780-001-11

ADDENDUM NO. 1

Freeman Public Schools
 Adams, Nebraska
 TCEP No.: 780-001-11

Addendum #01
Supplemental Drawing: SDM-001
Revision of Sheet: M1.00
Date: 09/26/12

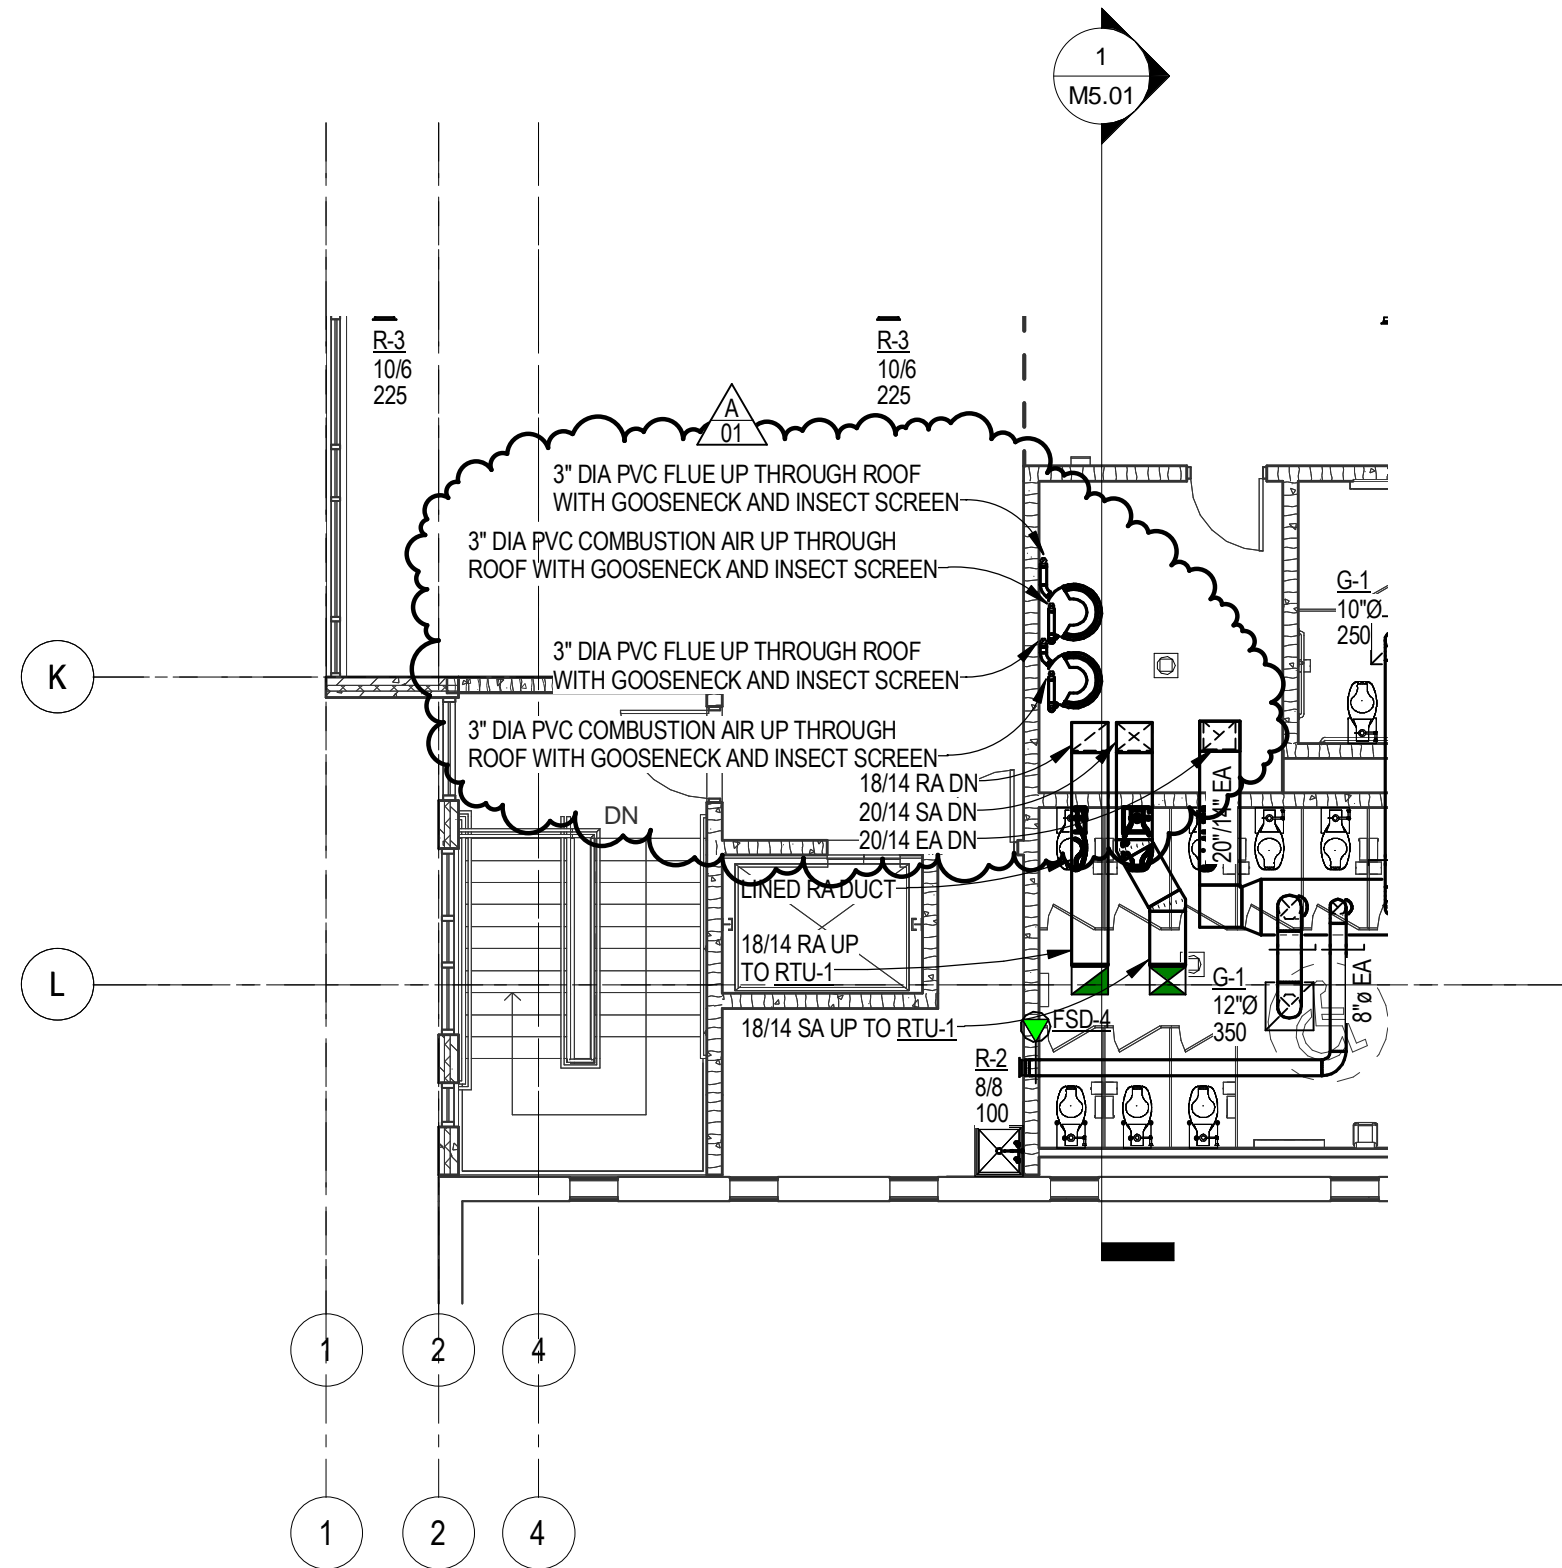
Refer to attached supplemental drawing SDM-001 for changes exhaust duct serving Women's Shower 022.

Addendum #01
Supplemental Drawing: SDM-002
Revision of Sheet: M1.01
Date: 09/26/12

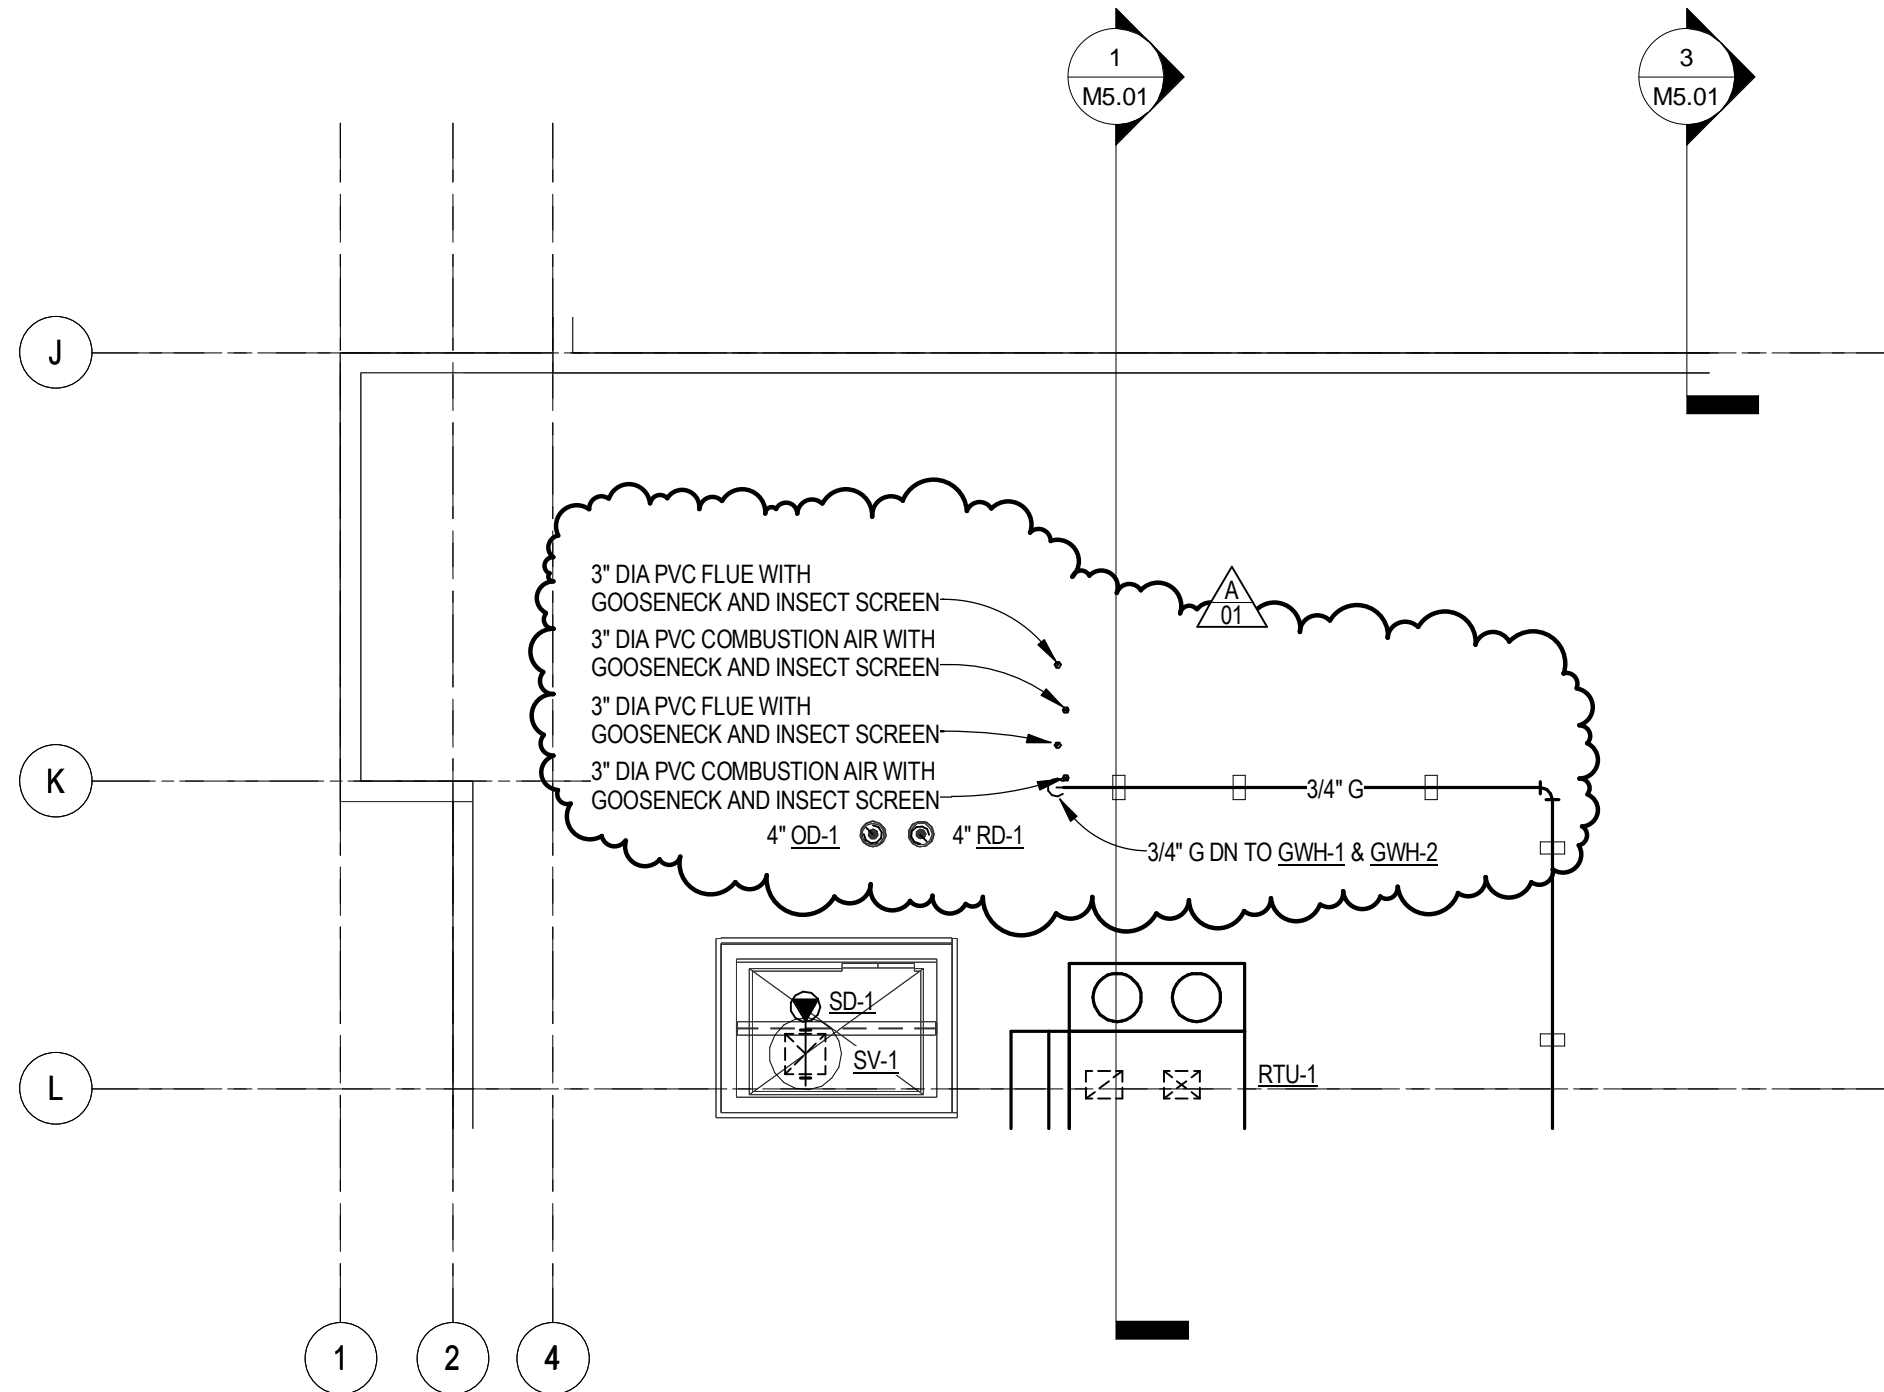
Refer to attached supplemental drawing SDM-002 for flue and combustion air for additional water heater.

Addendum #01
Supplemental Drawing: SDM-003
Revision of Sheet: M1.03
Date: 09/26/12

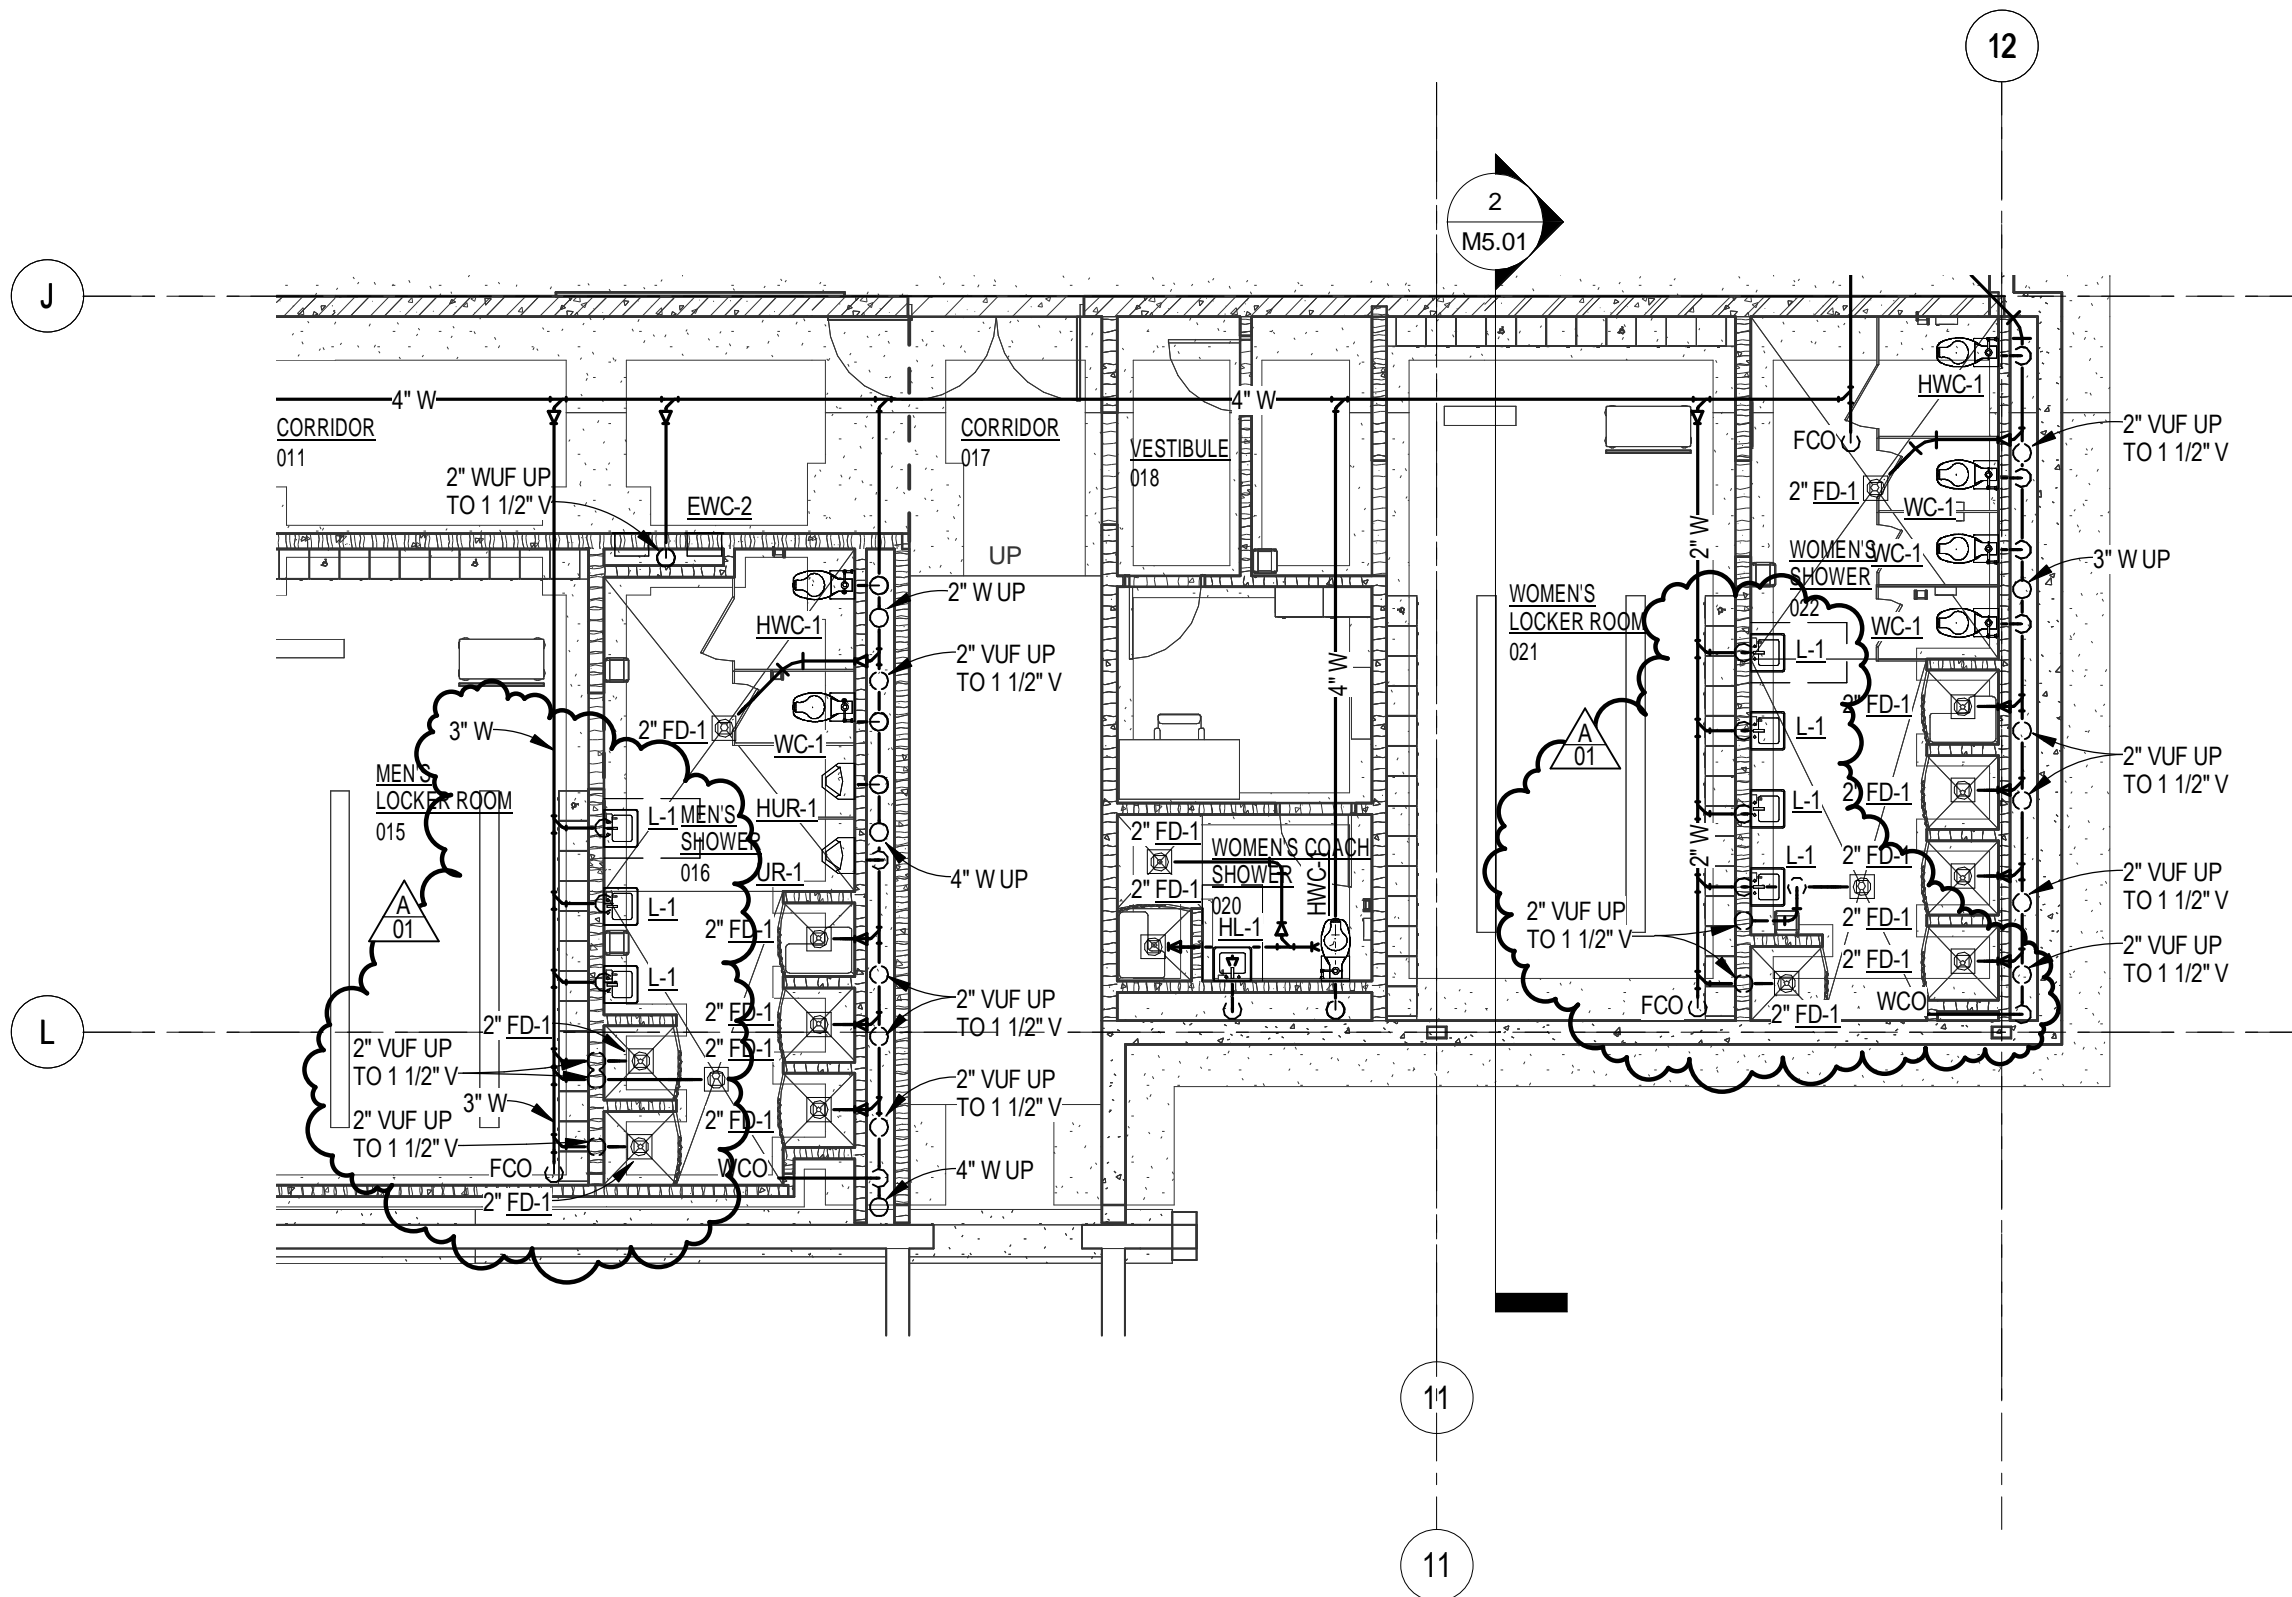
Refer to attached supplemental drawing SDM-003 for flue and combustion air for additional water heater and revised gas piping sizes.
